**ADDENDUM 1  
ASBESTOS ABATEMENT WORK PLAN**

**BOERNE INDEPENDENT SCHOOL DISTRICT  
OLD ADMINISTRATION BUILDING  
123 JOHNS ROAD  
BOERNE, TEXAS 78006**

**STC PROJECT 220469  
ORIGINAL WORK PLAN: OCTOBER 28, 2022  
DATE OF ADDENDUM 1: NOVEMBER 28, 2022**

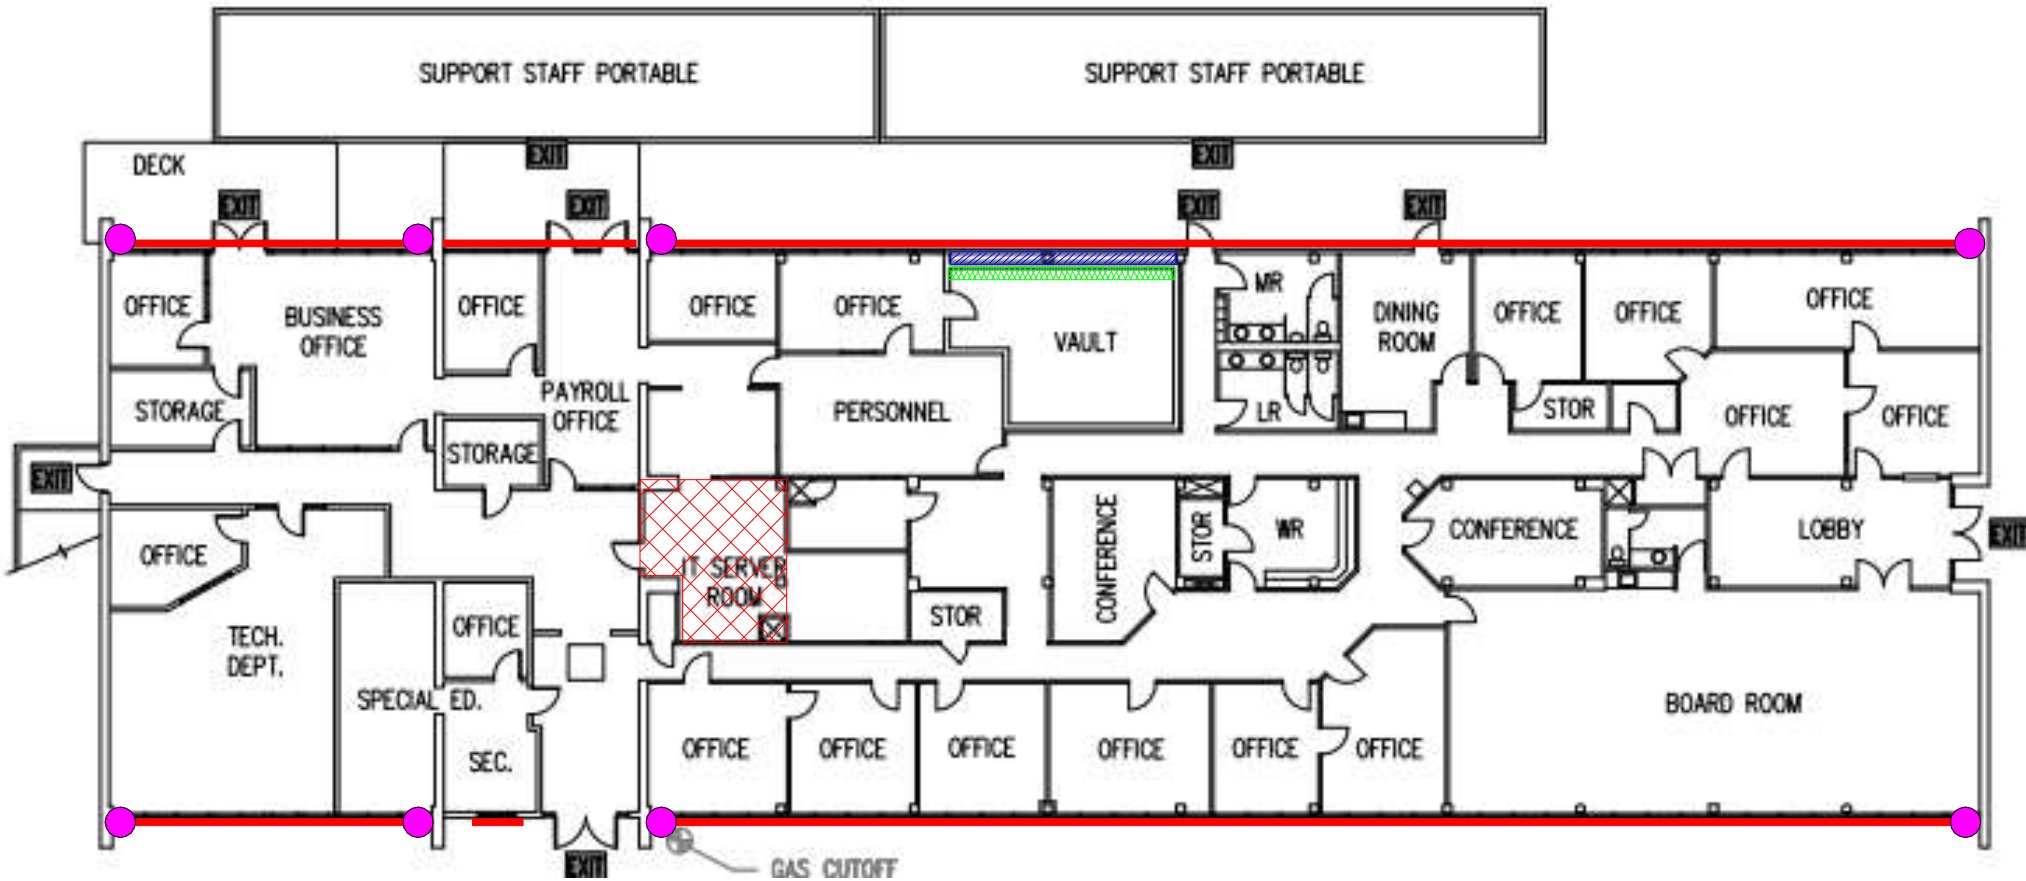
1. The removal of the entire metal, window frame system during the asbestos abatement is authorized for this project.
2. The Asbestos Abatement Contractor is responsible for building security following the component removal of the window frame system. The building shall be secured with plywood or OSB panels with a minimum thickness of ¼”.
3. The Asbestos Abatement Contractor is responsible for the demolition of the 270 ft<sup>2</sup>, non-asbestos-containing CMU block wall located in the vault. The demolition of this wall is necessary to access the asbestos-containing, vinyl floor tile system enclosed between the vault wall and the exterior wall of the building.

A Quote Sheet for the asbestos-abatement activities noted in the Work Plan and for the above-mentioned tasks is attached. A revised floor plan is presented in the attached Figure 1B. Questions concerning this Addendum should be directed to our office at (210) 696-6286.

Window Glazing - Approx. 525 SF or 670 Window Panes (40"x16")  
Component Removal of Entire Metal Frame System is Authorized

Window Caulking - In Between Metal Window Frame and  
Exterior Brick Veneer - Approx. 6 SF - Eight (8) Separate Areas

NOTE: Asbestos Abatement Contractor is Responsible for Building  
Security Following Window Removal - Minimum 1/4" Plywood or  
OSB Panel
